**ENVIRONMENTAL IMPACT STATEMENT**  
**ON**  
**CONTINUED OPERATION OF THE**  
**HANFORD GENERATING PROJECT**

**WASHINGTON PUBLIC POWER SUPPLY SYSTEM**

**JANUARY 1977**

Figure 3.1-2  
Elevation vs. Flow at Columbia  
River Mile 380.0

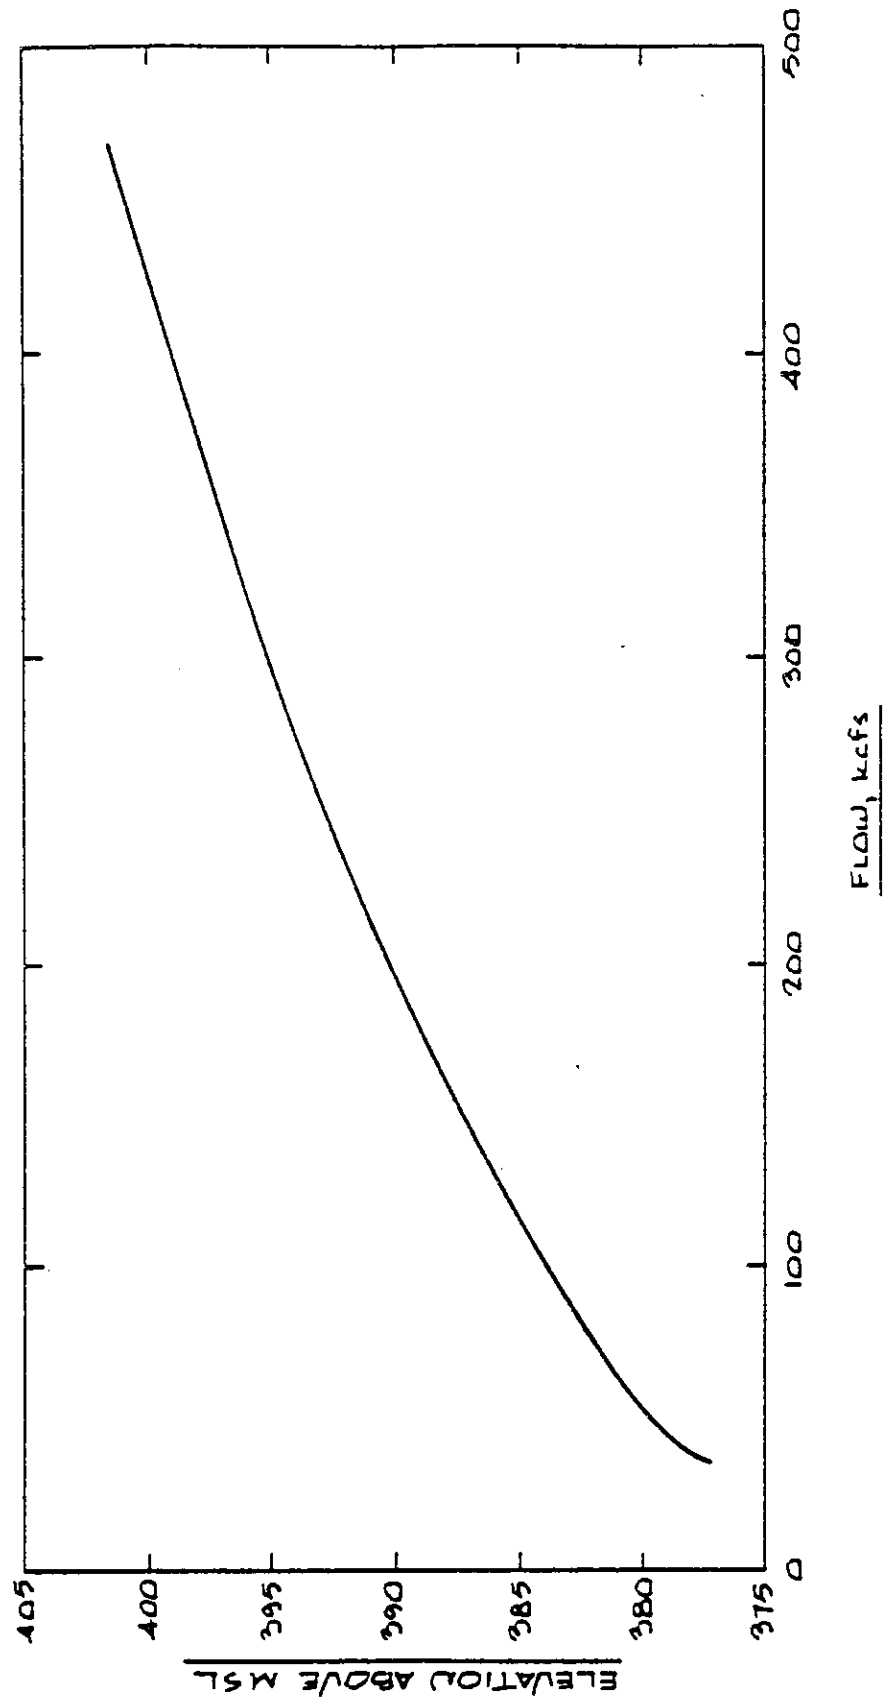
10. Figure 3.1-2 should show river mile points in order to help the reader locate the area under consideration.

16. River mile indices have been added to Figure 3.1-2.

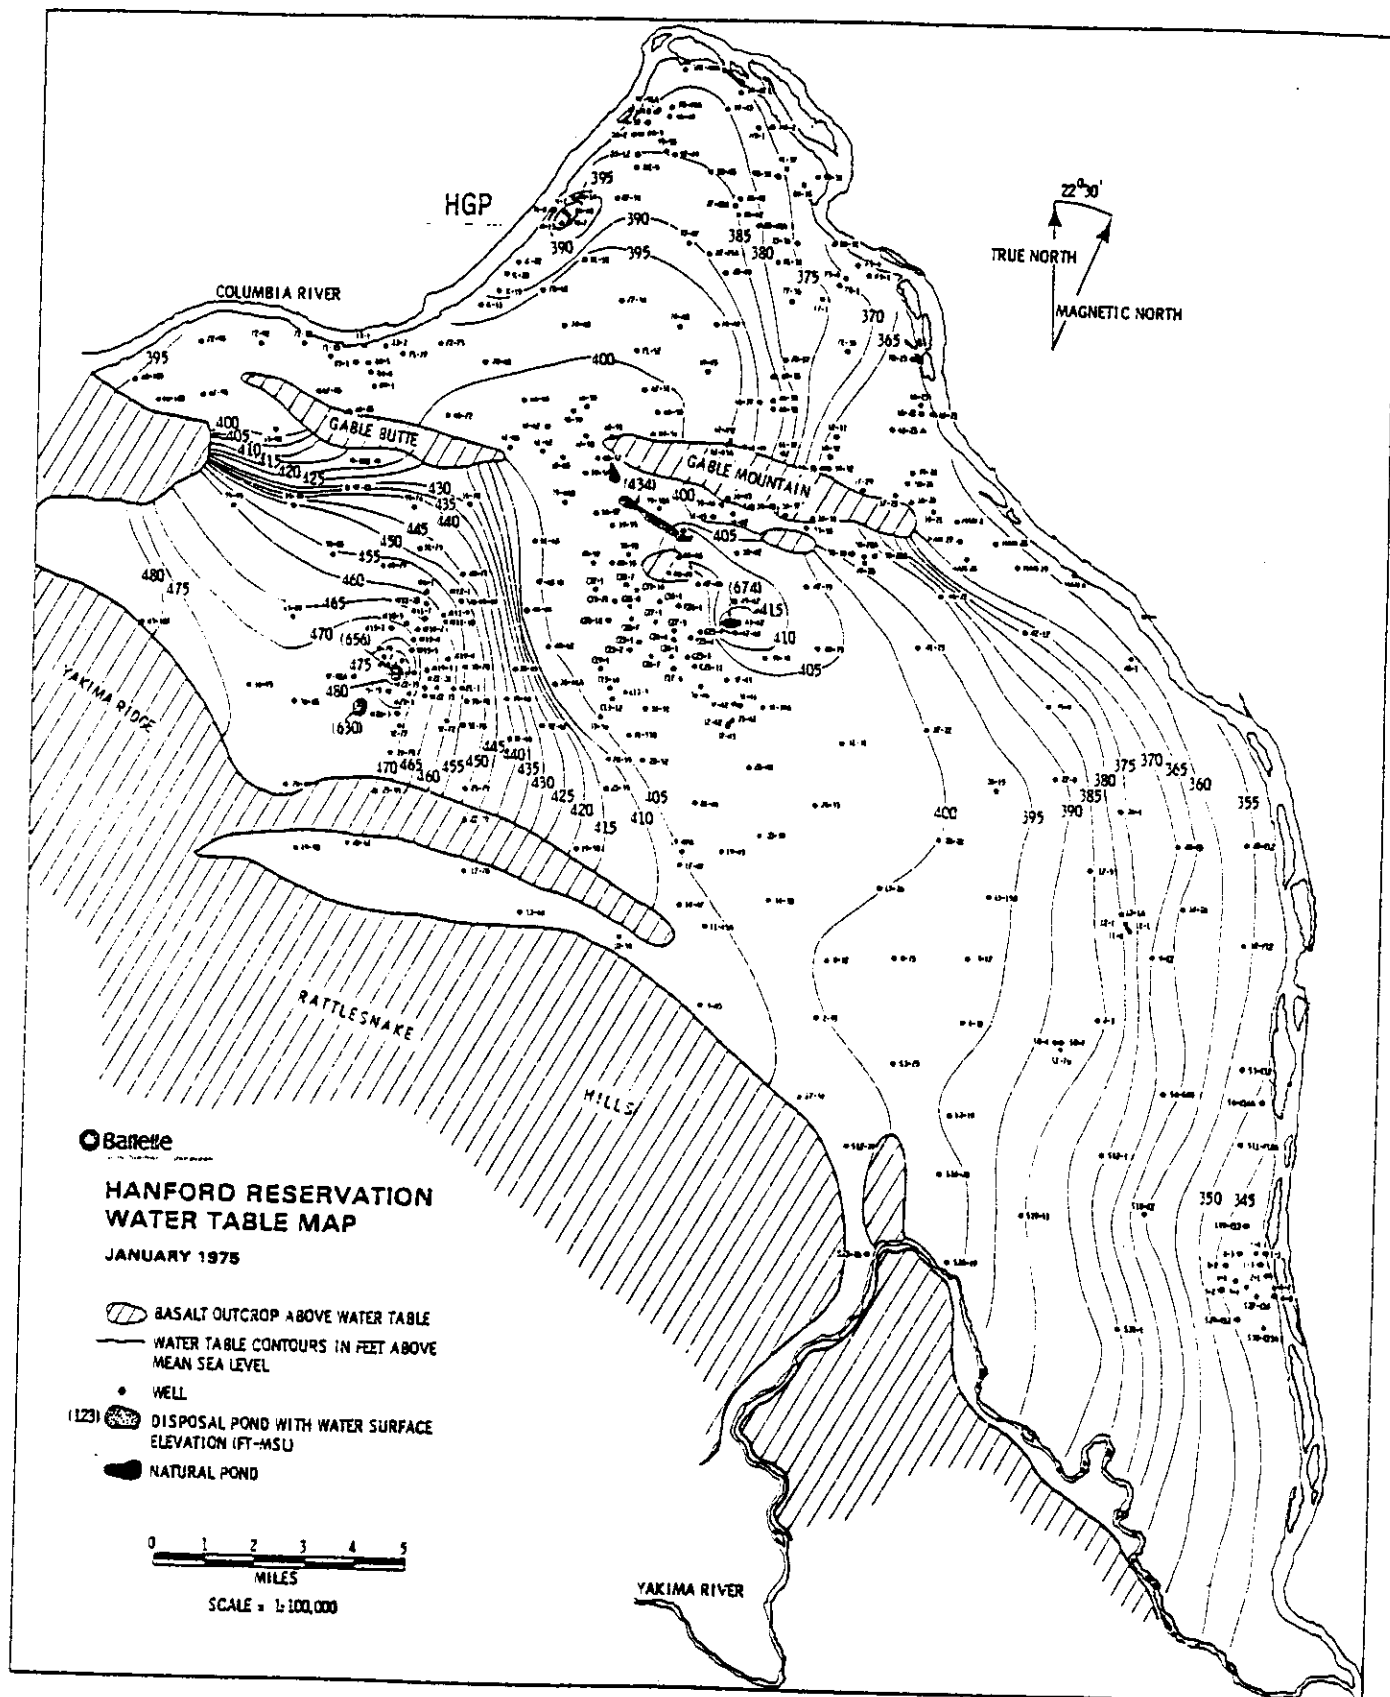
Page 3-13 - Figure 3.1-5 is not the most recent ground-water table contour map. For a more recent map (January 1975) see ERDA-1538, Vol. 2, Page 11.3-23, Figure 11.3-15.

Figure 3.1-6  
Summary of Species and Activities  
for Anadromous Fish in the Hanford  
Reach of the Columbia River

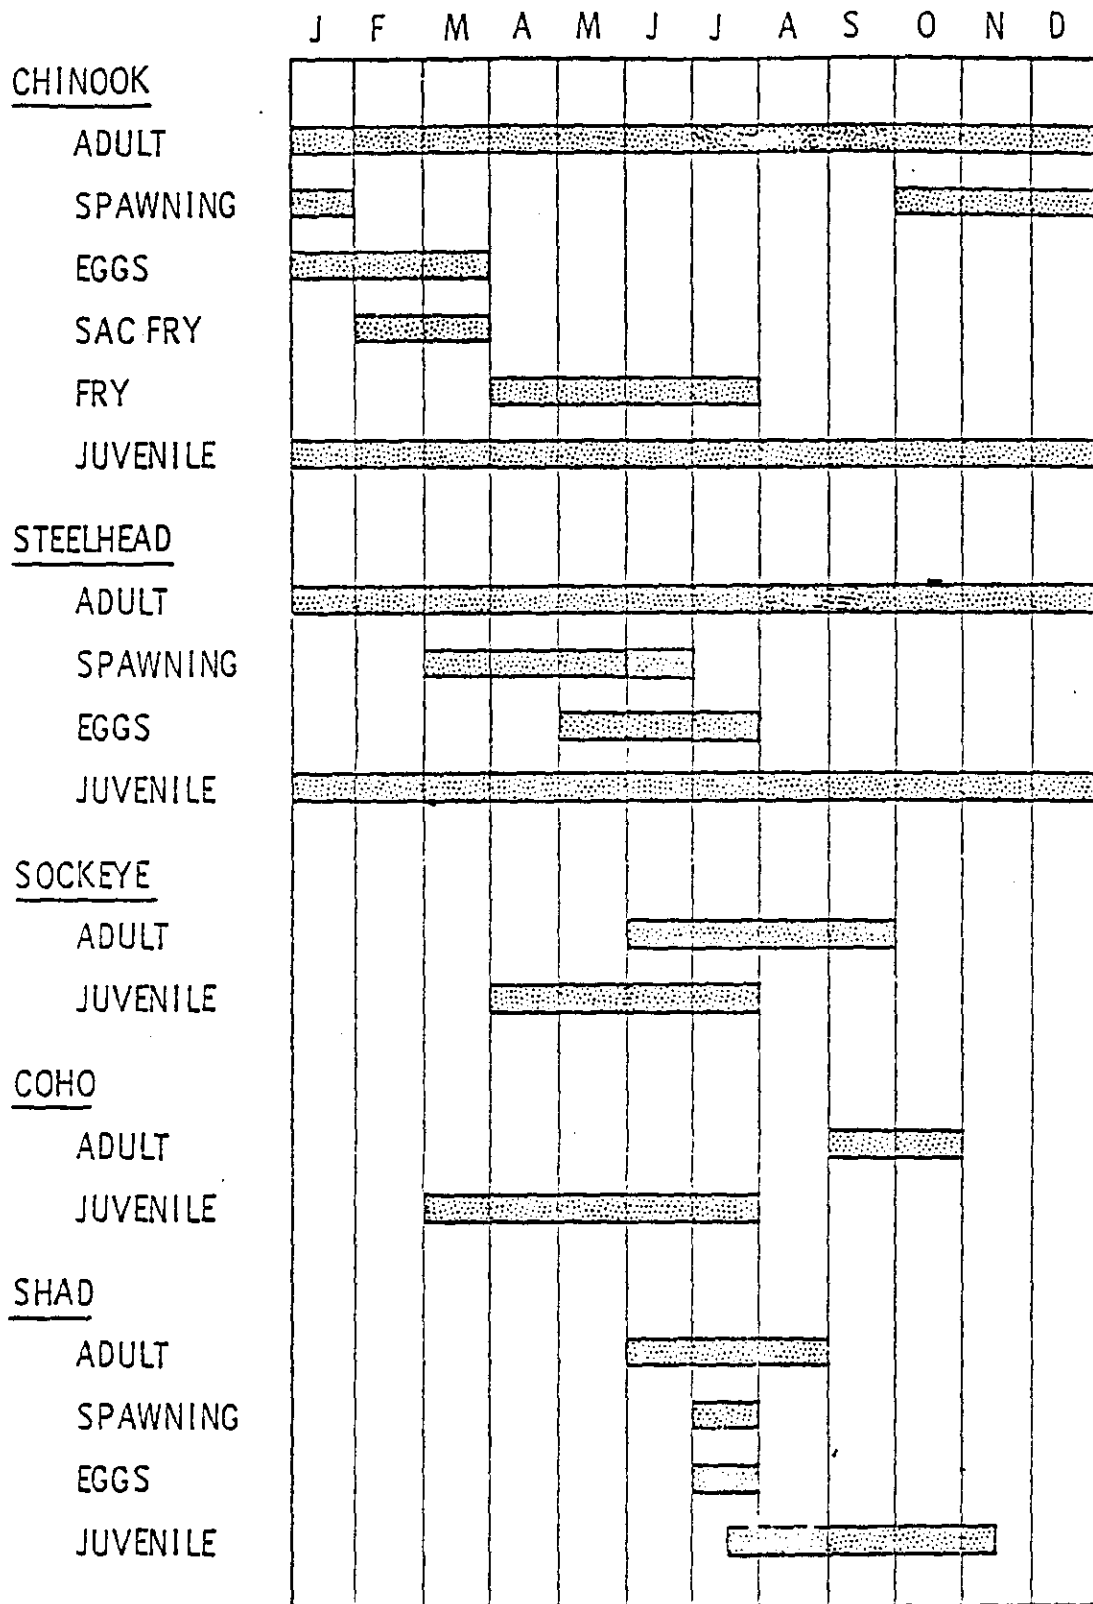
Page 3-22, Figure 3.1-6. Yolk sac fry are present in the gravel at least through April 10. We recommend that the figure show sac fry in the gravel through April.

4. While some sac fry may be present in the gravel in April, the fry emerge from the gravel primarily in February and March.
5. The appropriate change has been made in the final EIS.
6. See response number 4 to comments above.
7. The alternative modifications of the discharge diffuser are discussed in Section 8.3.1.
8. The effluent becomes fully mixed with the river between 3 and 4 miles downstream of the discharge as shown in Figure 4.1-7(b). We appreciate your value judgement that once the effluent has mixed fully with the river it is of lesser concern.
9. See response number 4 to comments above.

Figure 4.1-8  
Vertical Temperature Profile  
Downstream from End Port

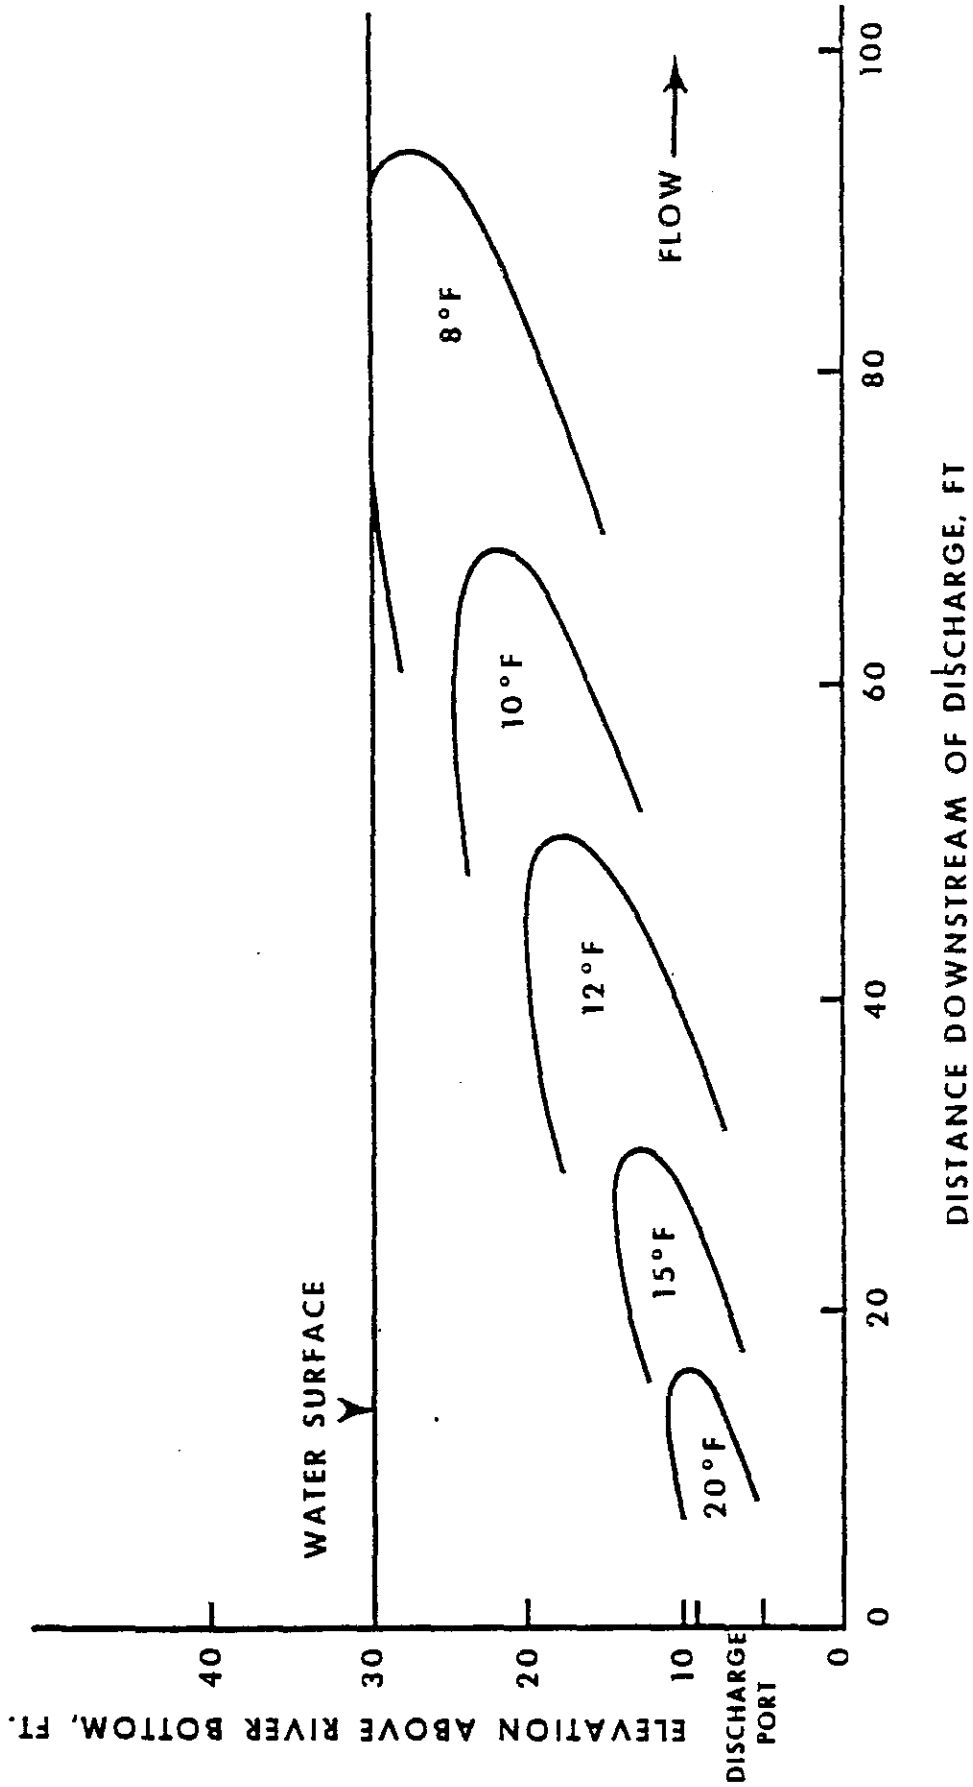
Page 4-8, paragraph 4. Figure 4.1-8 should indicate how far downstream the effluent becomes fully mixed with river water. We are primarily concerned with adverse effects to fish life within the mixing zone and not as concerned after the effluent has been fully mixed with river water.

8. A discussion of the combined affects of the two plumes has been added to Section 4.1. A vertical profile of the HGP discharge has been added as Figure 4.1-8. See response number 7 above for a discussion of DOE's mixing zone policy.

17. A figure showing the vertical and near field temperature profile of the HGP plume downstream from the end port has been added as Figure 4.1-8.
